STATE OF TENNESSEE
DEPARTMENT OF TRANSPORTATION
NASHVILLE, TENNESSEE 37243-0350

INSTRUCTIONAL BULLETIN No. 02-08

Regarding Standard Drawing To Be Printed With The Plans
When Attaching Guardrail to Top Slab
of Box and Slab Culverts and Bridges

<input type="checkbox"/> SHOW REVISION -- FINE APPROVAL NOT REQUIRED.
STATE OF TENNESSEE DEPARTMENT OF TRANSPORTATION GUARDRAIL ATTACHMENT TO CONCRETE DECKS OF BOX AND SLAB CURBS AND BRIDGES
6-22-89
S-GR-22

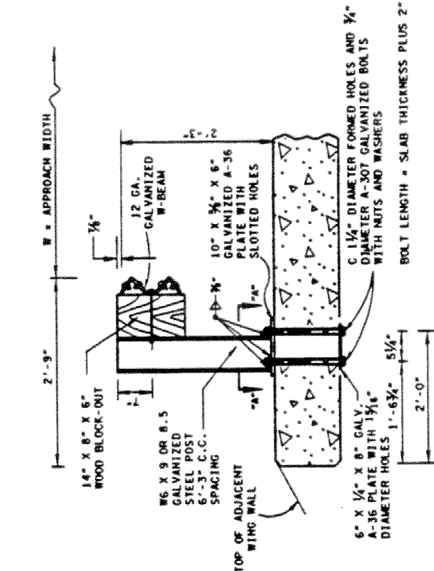
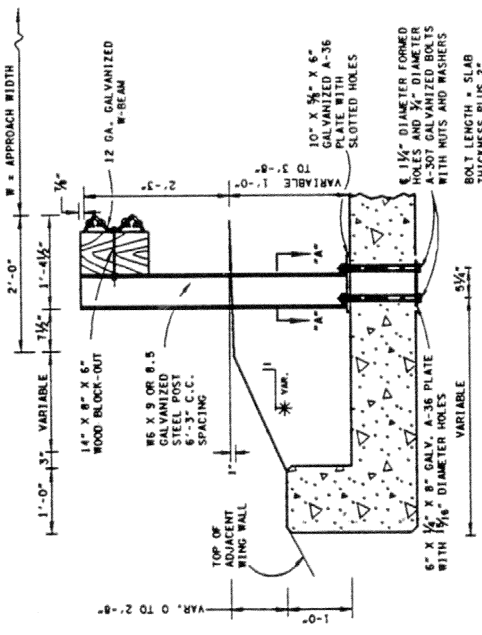
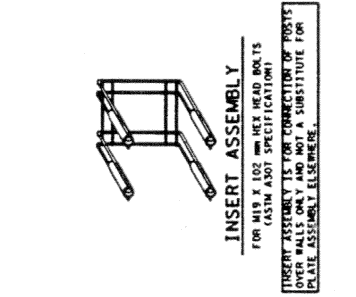
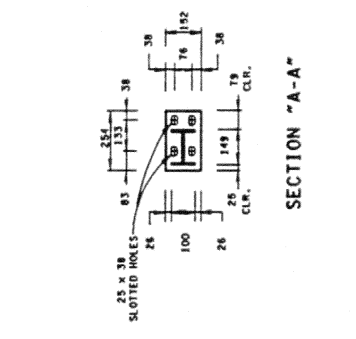
Effective for the July 26, 2002 letting, when attaching guardrail to the top slab of box and/or slab culverts or bridges, the following revised standard drawings are to be printed with the plans. They shall be identified on the lower left hand corner of the index sheet - "**To be printed with the plans.**"

- REV. 8-5-97, MODIFIED INSIDE ELEVATION OF GUARDRAIL DETAIL.
- REV. 7-29-94, CHANGED STEEL WOOD BLOCK-OUT DIMENSIONS IN ALL DETAILS AND NOTES.
- REV. 5-27-91, RELOCATED 1 1/4" SLOTTED HOLES OUTWARDLY 1 1/4".
- REV. 10-26-90, ELIMINATED CONCRETE DECK PANELS FOR HEIGHT OF FILLS OVER 1'-6". CHANGED DESIGN ITEM 10.
- REV. 9-27-01, CHANGED ITEM NO. 105-06.01 TO 105-01.04.
- REV. 4-15-02, CHANGED SHEET NAME, ELIMINATED DETAILS FOR PRECAST, PRESTRESSED CONCRETE DECK PANELS. CHANGED ITEM NO. 105-06.01 TO 105-01.04.
- REV. 1-6-88, CHANGED TYPE OF CUB TO COMPLY WITH NEW STANDARD DRAWINGS STD-15-6 AND STD-15-7.

SM-GR-22
11-1-78

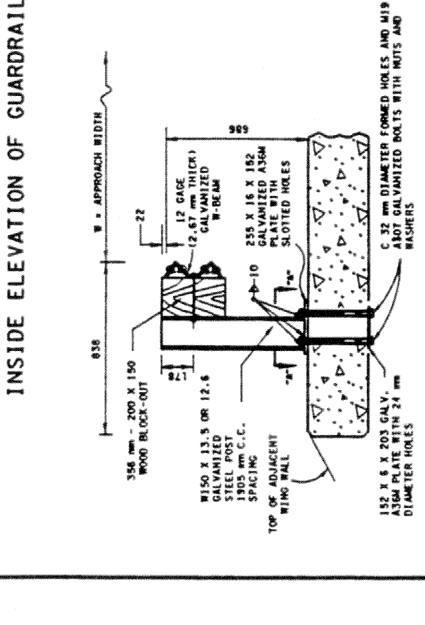
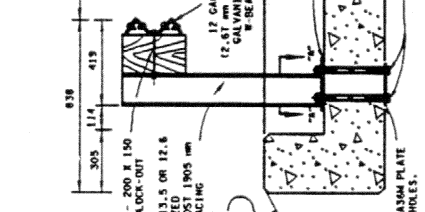
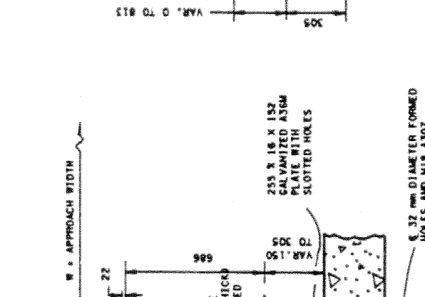
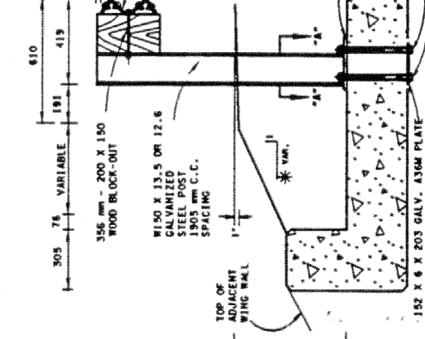
- REV. 11-1-78: CHANGED TO METRIC.
- REV. 2-29-78: MAKE MINOR DIMENSIONING CHANGES.
- REV. 8-2-78: MODIFIED DRAWING ELEVATION OF GUARDRAIL DETAIL.
- REV. 2-28-79: CHANGED STEEL BLOCK-OUTS TO WOOD BLOCK-OUTS IN ALL DETAILS AND NOTES.
- REV. 8-27-81: RELOCATED 32 mm DIAMETER FORMED HOLES OUTWARDLY 54 mm.
- REV. 10-24-81: ELIMINATED DETAILS FOR CONNECTION OF POSTS TO CONCRETE DECK PANELS FOR HEIGHT OF FILLS OVER 455 mm. CHANGED DESIGN NOTE 2, TO SHOW 01 TO 105001-04.
- REV. 4-18-82: CHANGED ITEM NO. 4 ELIMINATED DETAILS FOR PRECAST. PANELS FOR HEIGHTS LESS THAN 455 mm. CHANGED TYPE OF CUBER TO DRAWINGS STD-15-6 AND STD-15-1.
